- ERRATA -

for PCI Design Handbook Second Edition (MNL-120-78)

PCI Design Handbook-Precast, Prestressed Concrete Second Edition

(MNL-120-78)

Fig. 2.6.5 Partial interaction curve for prestressed solid wall panels

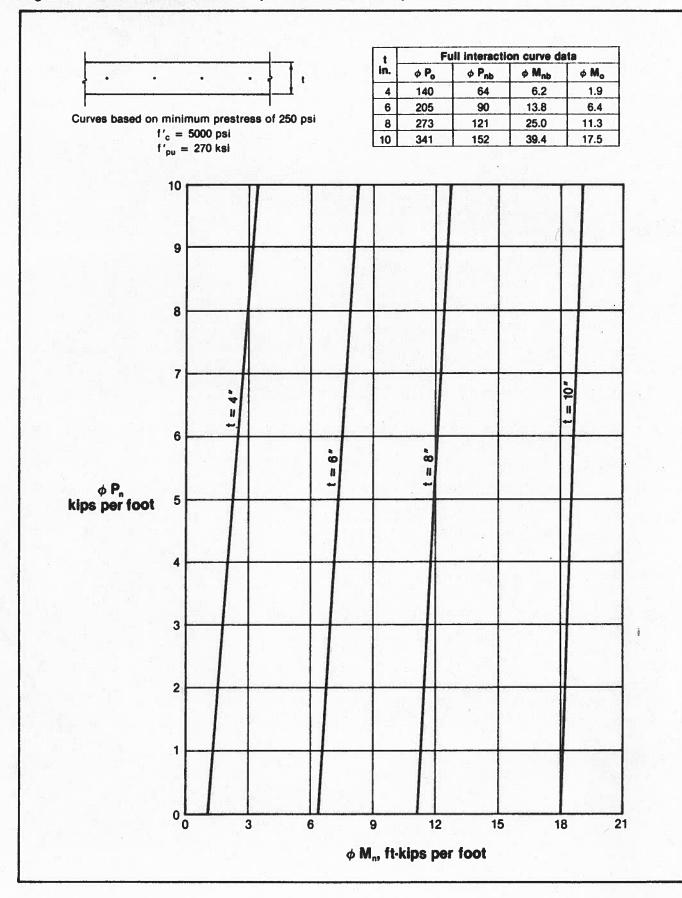
page 2-53 – In table of safe superimposed load: change third column heading to e_{e} v'_{tc} to include λ (see correction 3-43)	for page
page 2-60 – Plots for 6-in. and 8-in. walls are incorrect (see attached) page 3-71 – Fig. 3.9.25: change abscissa scale R _v from 0 to 0.1, 0.1 to 0.2, etc.,

Fig. 4.7.10 Wind resisting elements for north-south wind

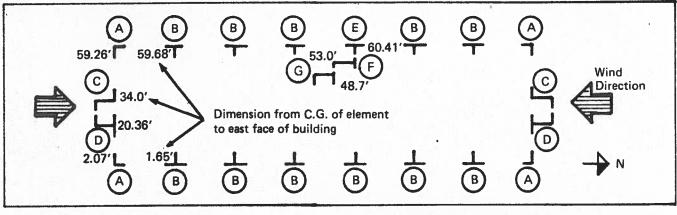
page 4-49 and pages 4-50 Second column, last line: change expression for K. + Kr to

$$\frac{1}{K_s} + \frac{1}{K_f} = \frac{3h_s}{EA_w} + \frac{h_s}{12EI}$$

This changes all subsequent calculations for Example 4.7.6 (see attached)
